PRODUCT/PROCESS CHANGE NOTIFICATION

PCN MMS-MIC/14/8685

Conversion to High Density Matrix Leadframe - LQFP 64

10x10 products listed below

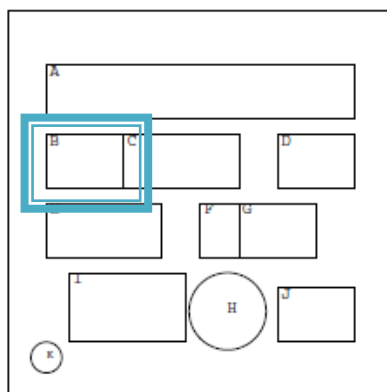
1/ For products listed below changing from STATS ChipPAC Shanghai (China) to Muar (Malaysia) assembly site:

The marking instruction indicated on the products is changing from:

B : Assembly plant changes from GH to 99

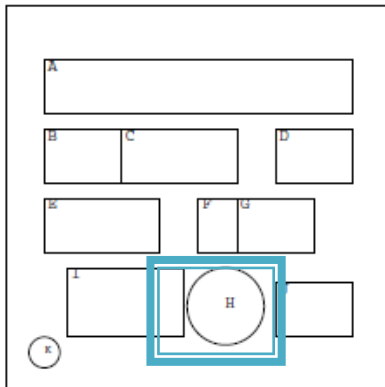
2/ For products listed below remaining at Muar (Malaysia) assembly site:

The marking instruction indicated on the products is changing from:

H : Second level interconnect changes from e4 to e3
